CONSTRUCTION PLANS FOR WALTON OAKS

CITY OF ROCHESTER HILLS, OAKLAND COUNTY, MICHIGAN

Site Plan Review
Reviewed for compliance with City Ordinance, Building and Fire Codes
Conditions and mark-ups noted throughout plan set must be addressed prior to final approval

BEFORE YOU DIG
CALL MISS DIG
1-800-482-7171

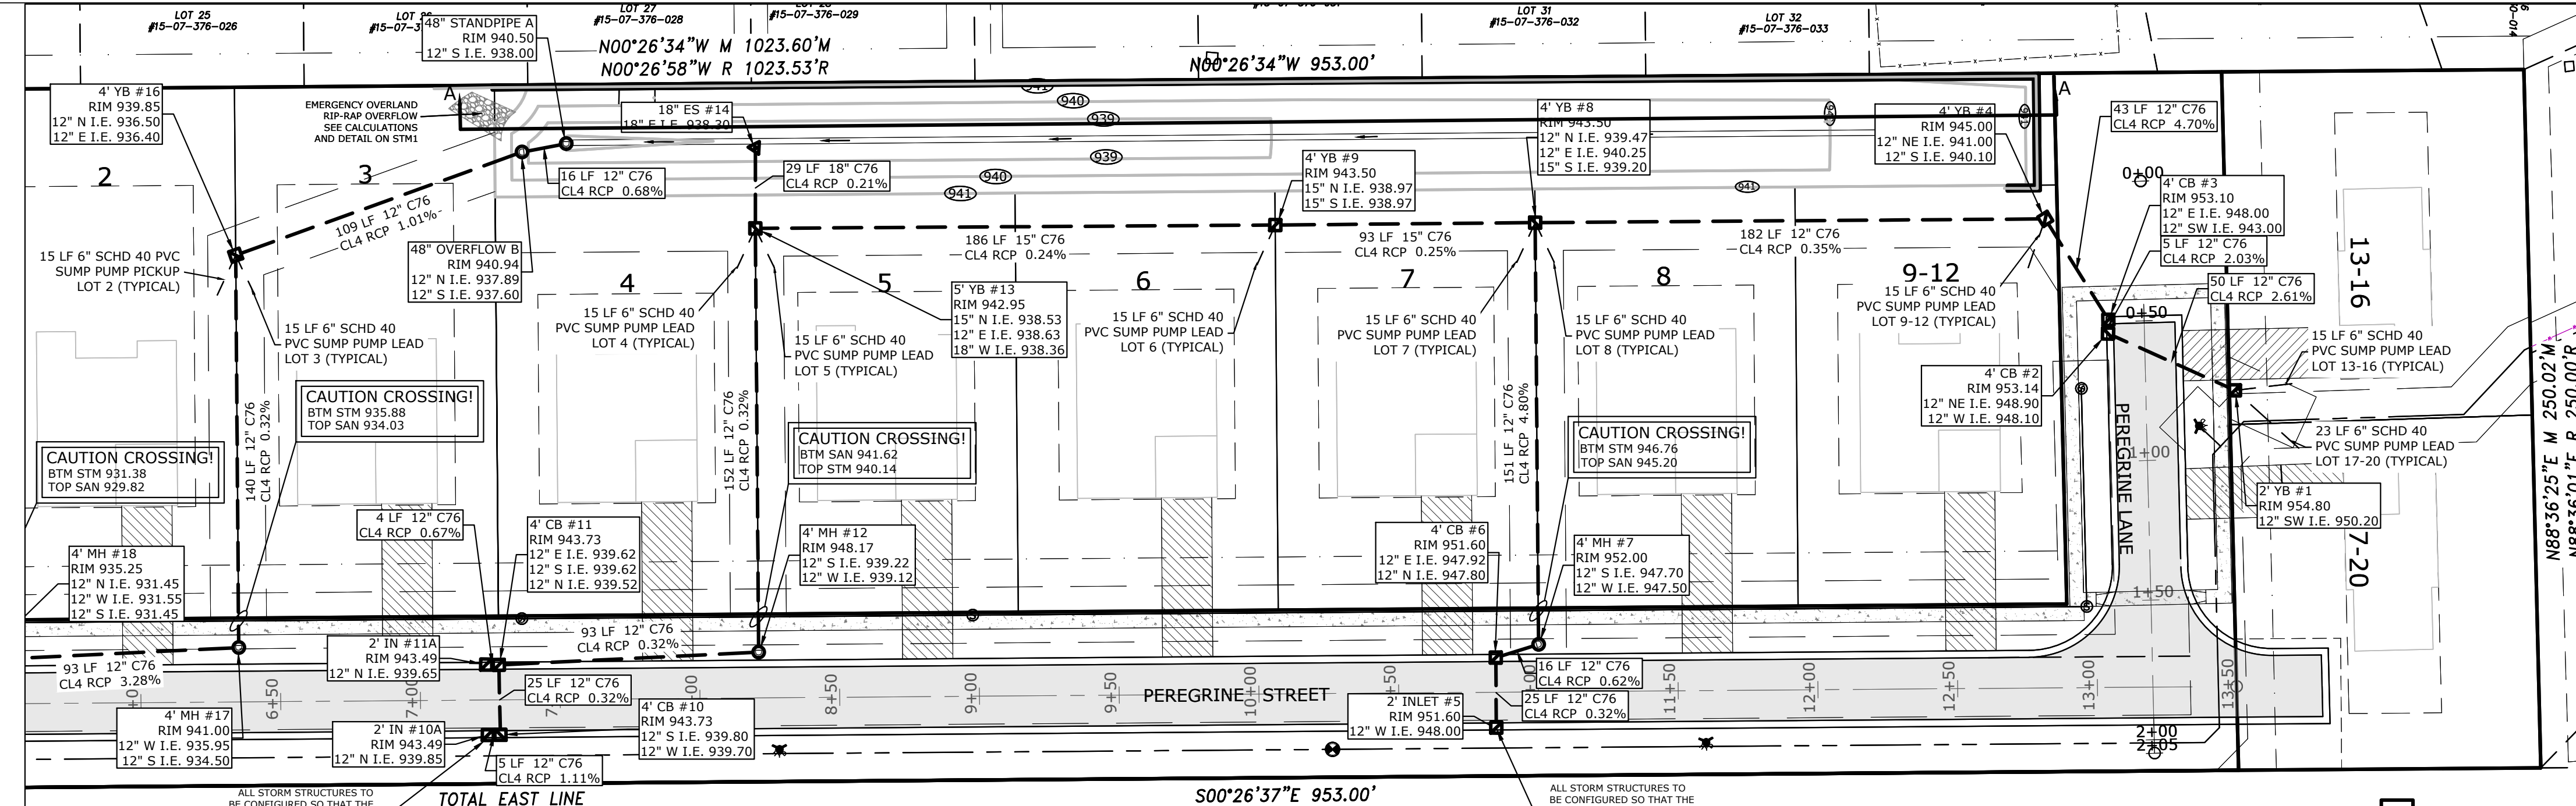
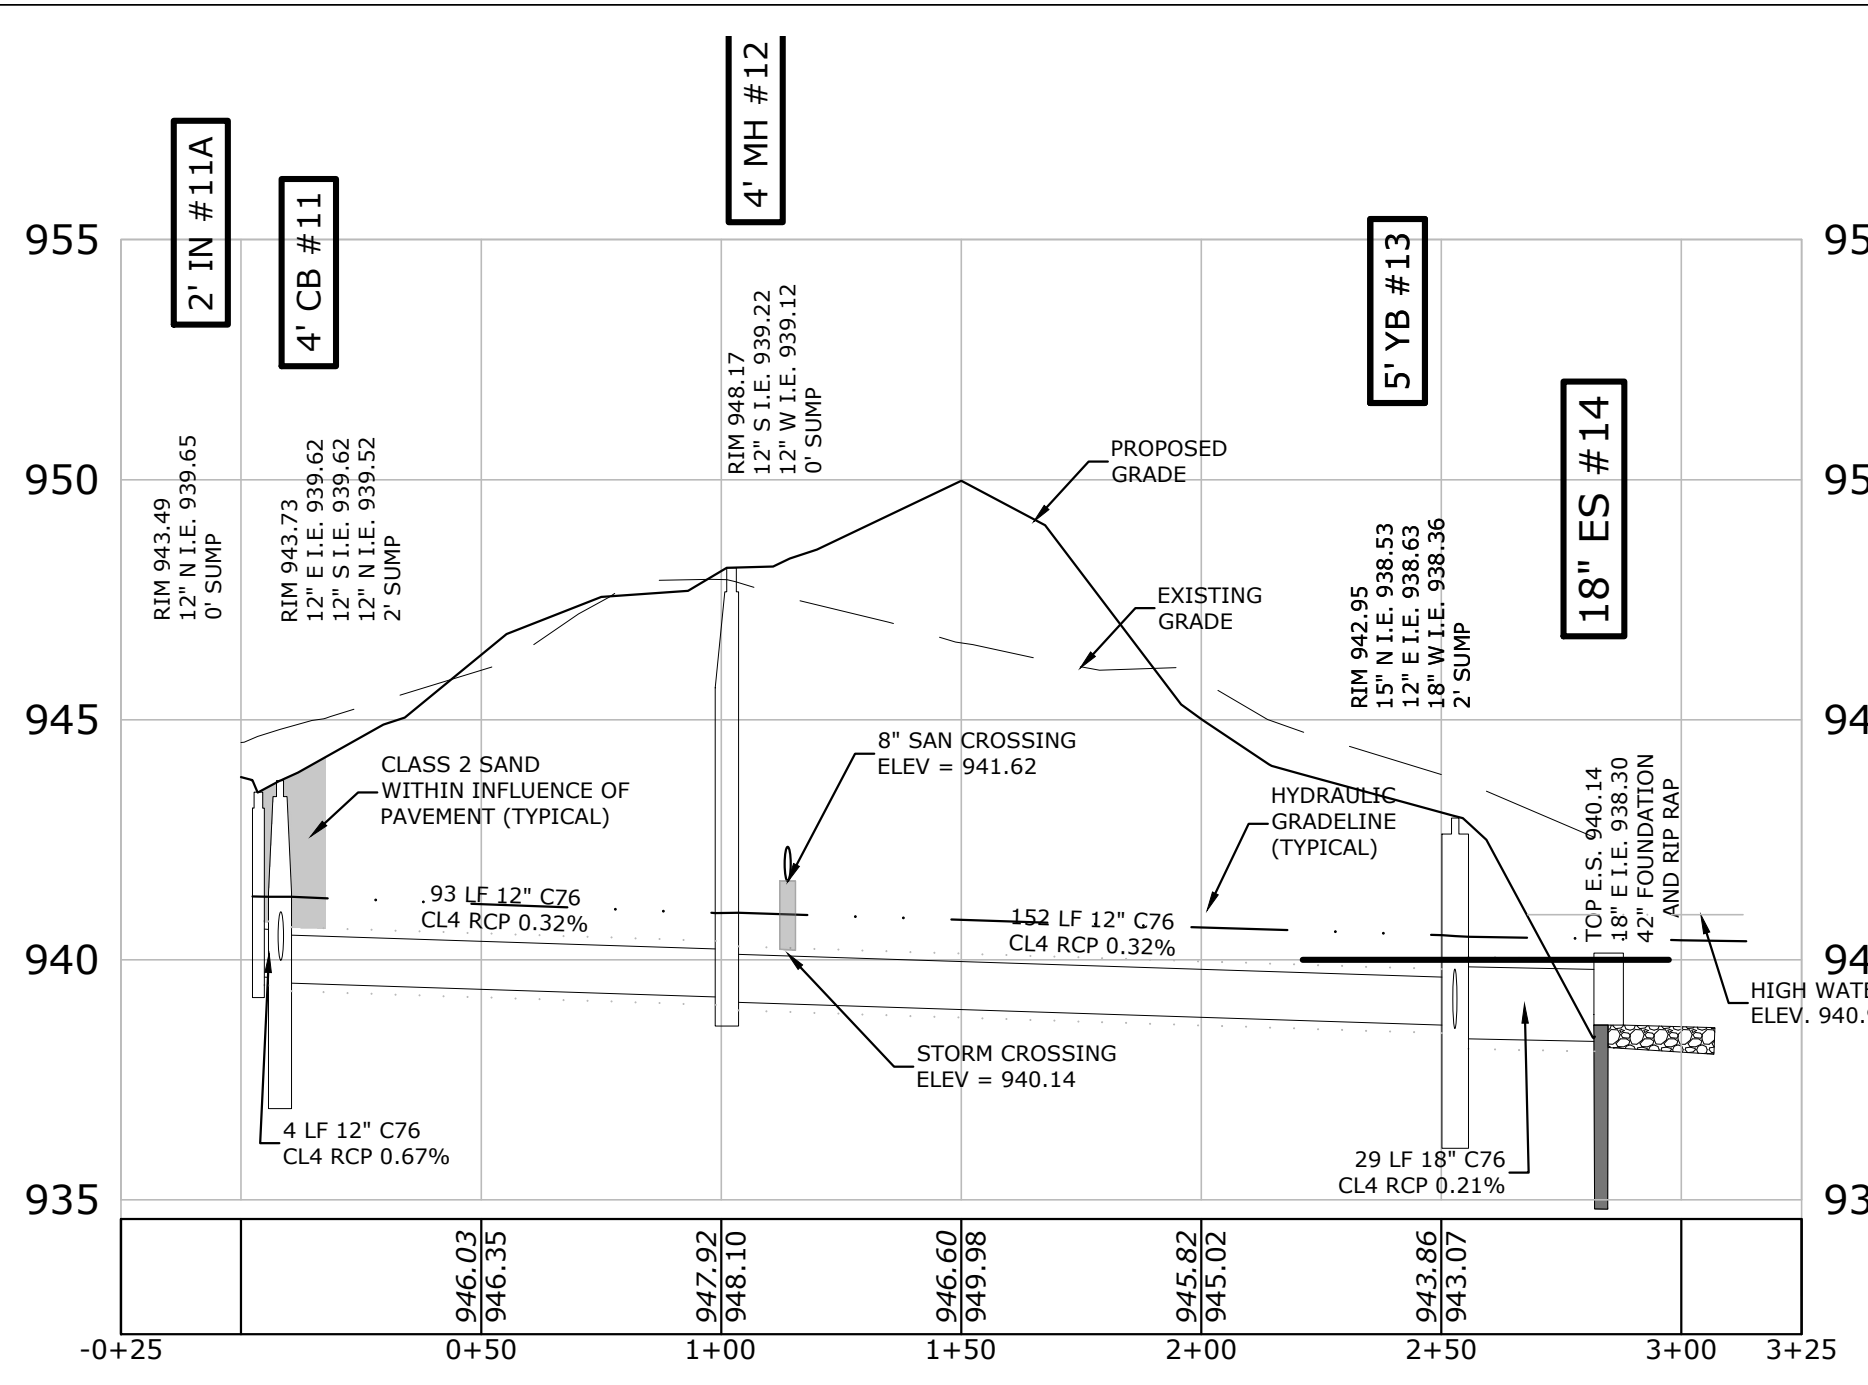
Revise elevations. The proposed elevation is lower than the overflow rim elevation.

STANDPIPE & RESTRICTED OUTLET DETAIL FOR STORM AREA 1 DETENTION POND

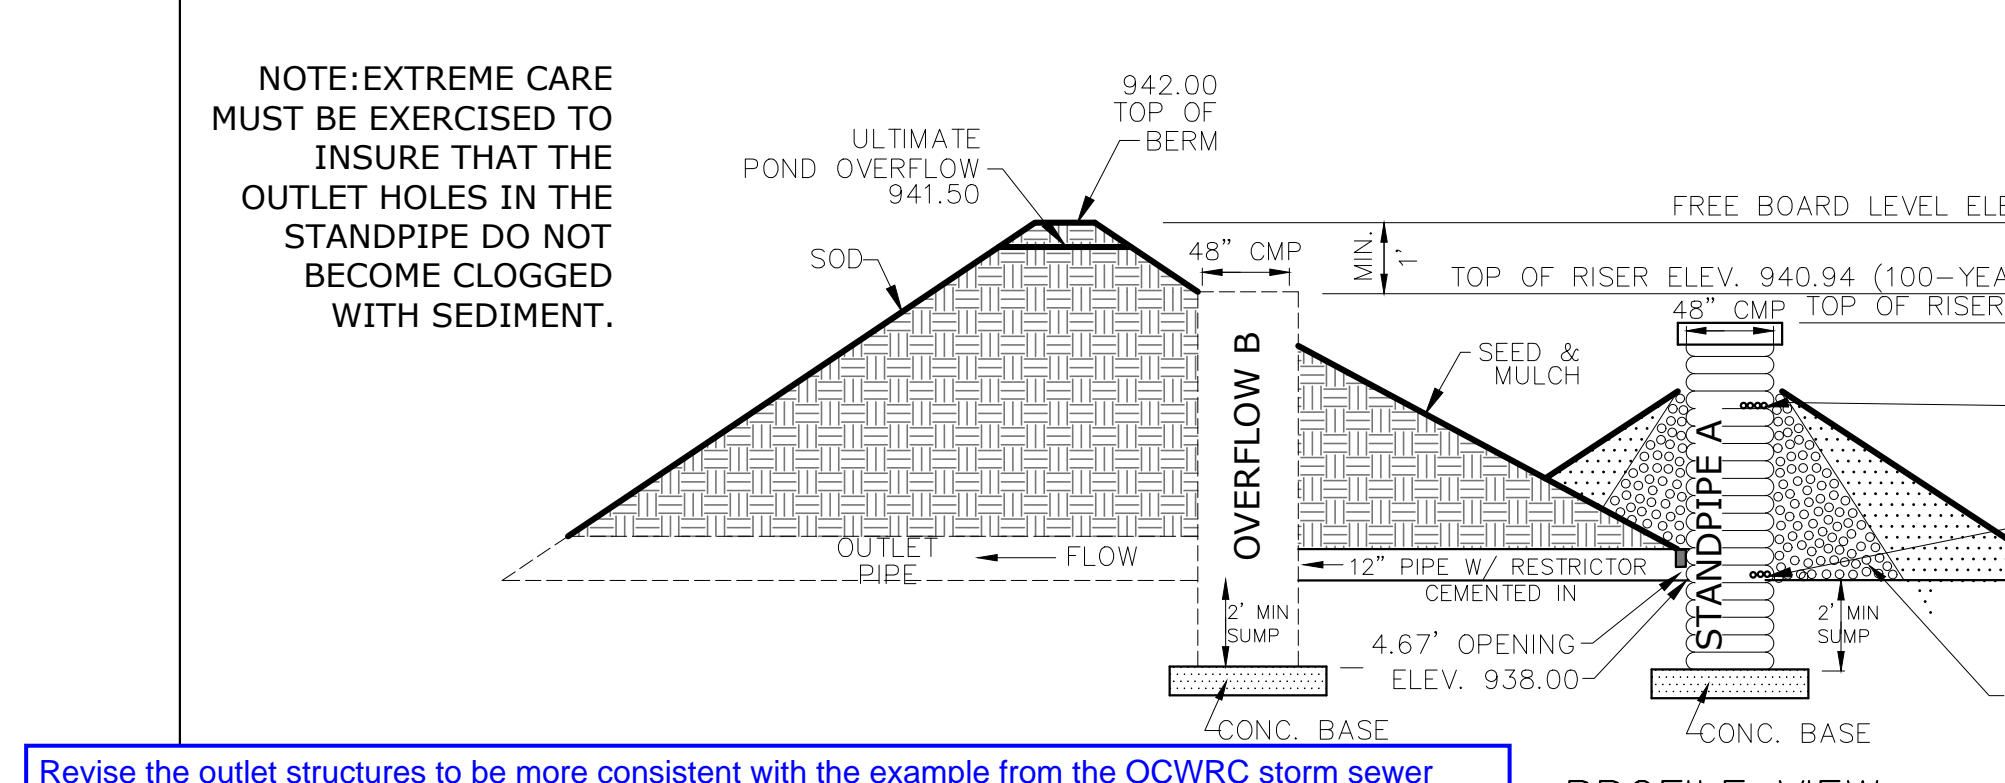
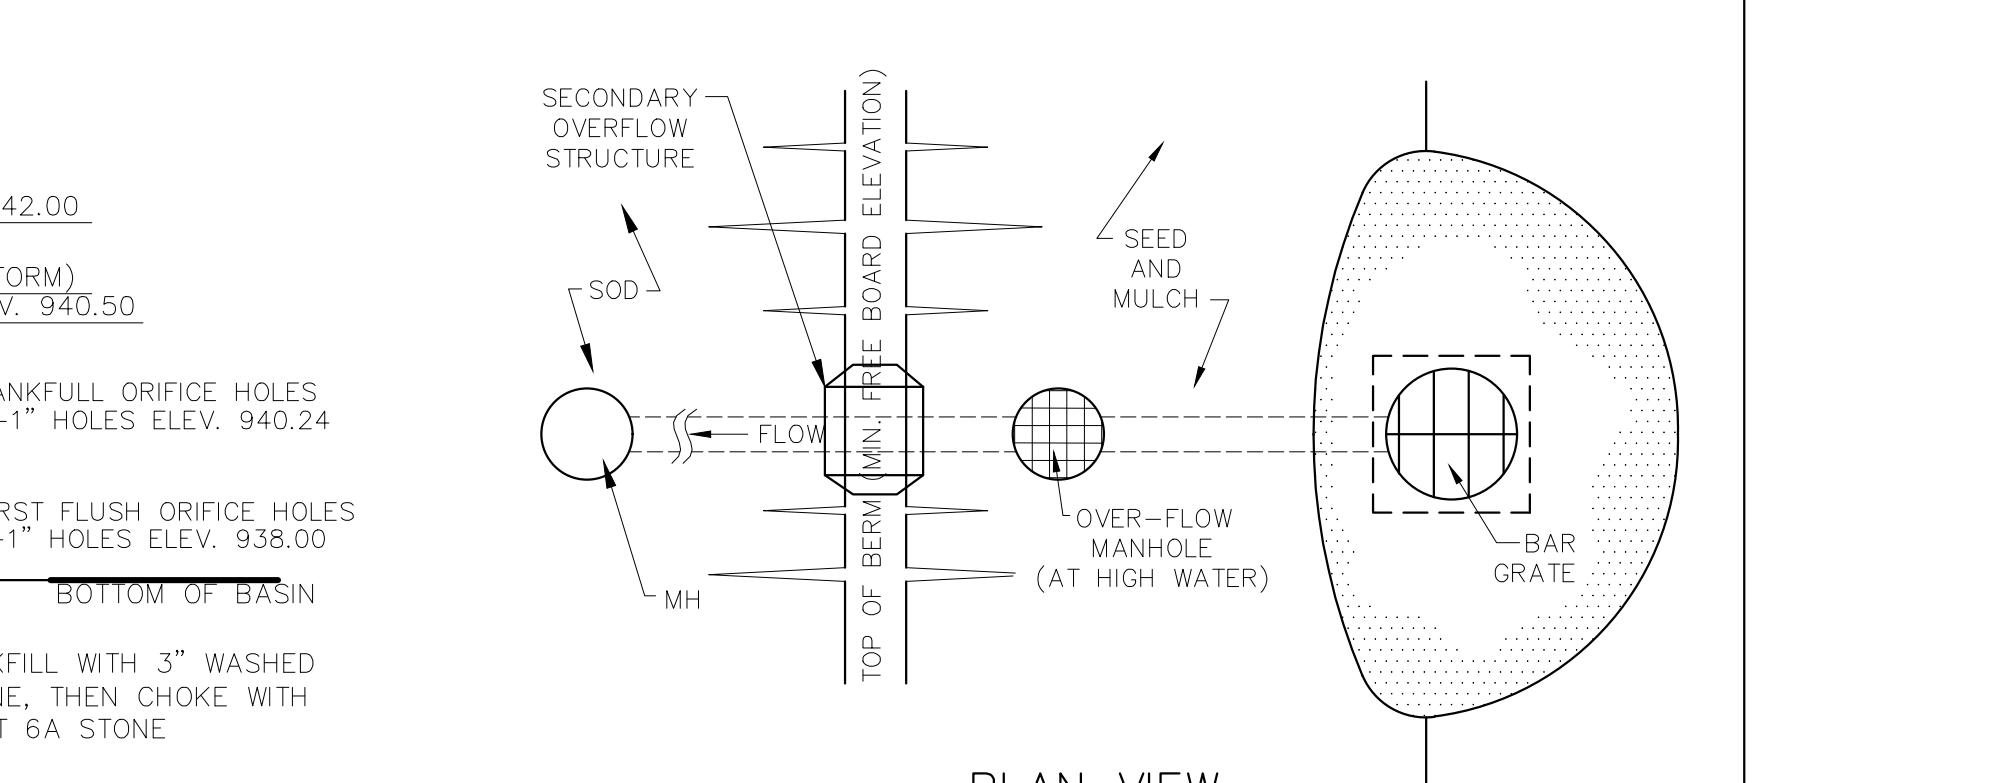
Revise the outlet structures to be more consistent with the example from the OCWR storm sewer standards on page 111. The two standpipes are encouraged, but the restrictors locations and the amount of them does not follow the example attached. Why the additional 4.67" cemented restrictor?
